ADVANCE NOTICE OF REVISION

(This notice **supplements** all earlier notices)

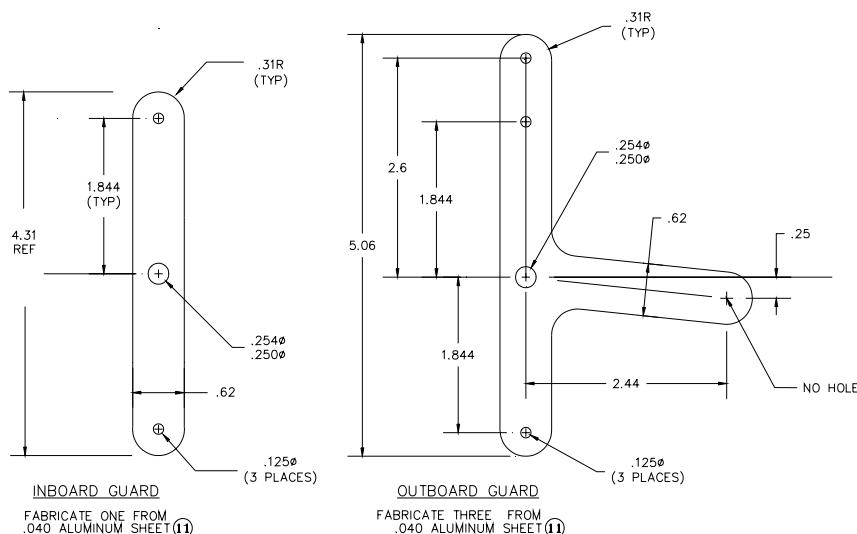
Page 53: Early cages had some variation between the bushings and tabs for the forward pulley group. A few cages may need longer bolts, namely an AN4-56 and AN4-47. The forward left pulley in figure 23 will be labeled as "elevator reversing pulley", the small center pulley is the "left rudder cable pulley" and the far right pulley is the "flap reversing pulley".

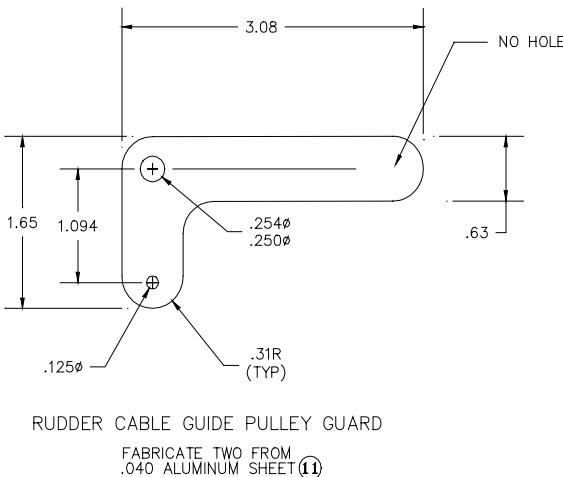
Page 54: The first sentence will change to make (3) outboard pulley guards. The sentence 'The second hole at 2.60" on the third pulley guard can be trimmed off as shown in the left side of Figure 23' will be added to the first paragraph.

The 1-27/32 dimension in the note will be changed to 1.844 for consistence with the figure. The shapes of the guards have changed and Figure 24 will be revised as follows:

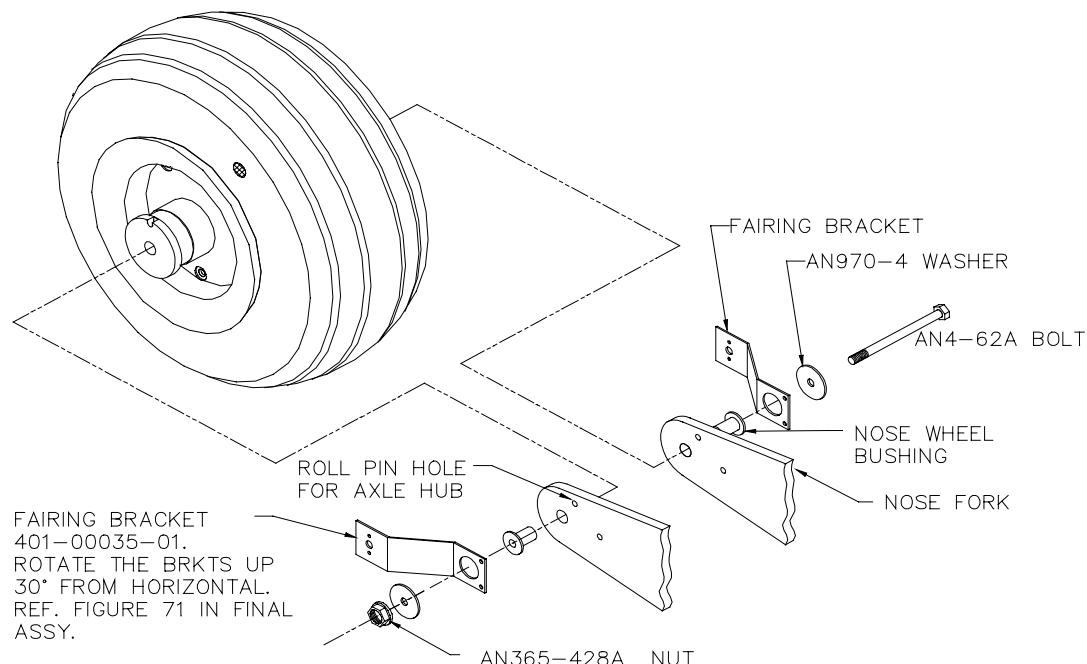
Page 244-246: A new method will be used to install the nose wheel pant to the nose wheel fork, which has made the installation easier. This will require a longer axle bolt AN4-62A, two brackets 401-00035-01 and two AN970-4 washers. These will be included in later kits. Step 85 will be reworded to install the two brackets and larger washer. The bracket is oriented on the nose fork with the aft end up 30 degrees to horizontal per Figure 71 in Final Assembly. Drill one 1/8

diameter hole through each bracket and into the nose fork arms. Install (1) 1/8" diameter x 1/2" roll pin 450-0070-002 in each bracket. Figure 138 will be revised as follows:

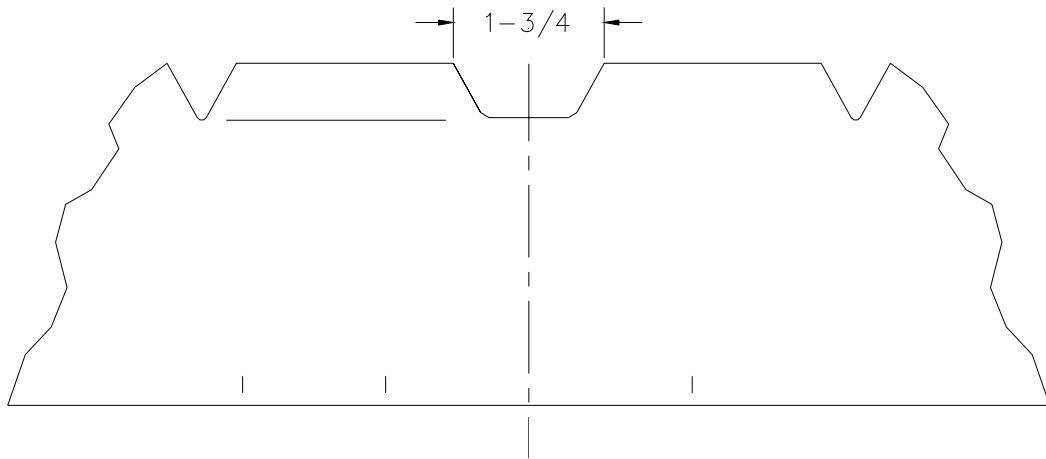
Page 21: The upper and lower flanges in Figure 3 will be changed to include a 1-3/4" wide notch located on the centerline as shown in the figure below. This notch allows for a better fit around the top center engine mount washer and bushing.

Figure 80: Inboard flap cove skins

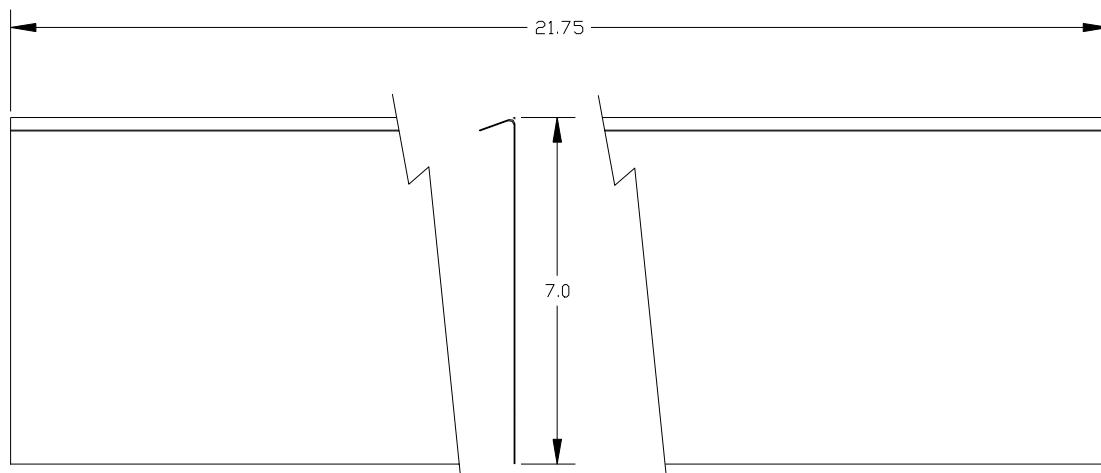
Figures 80-83 will be added to the instructions, which define the layout and trimming of all the cove skins.

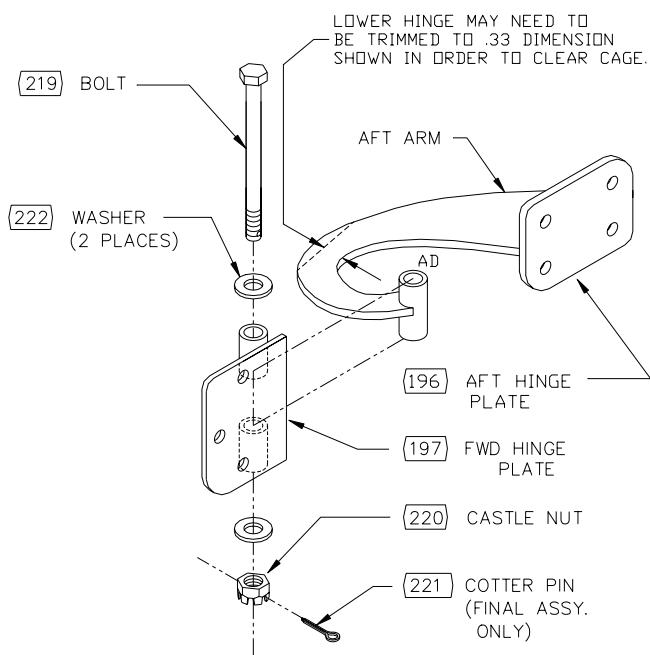
Page 239-242: The lower baggage door hinge has very little clearance to the cage tube. It is acceptable to relieve the arm of the lower hinge in this area as shown in the revised Figure 132 below.
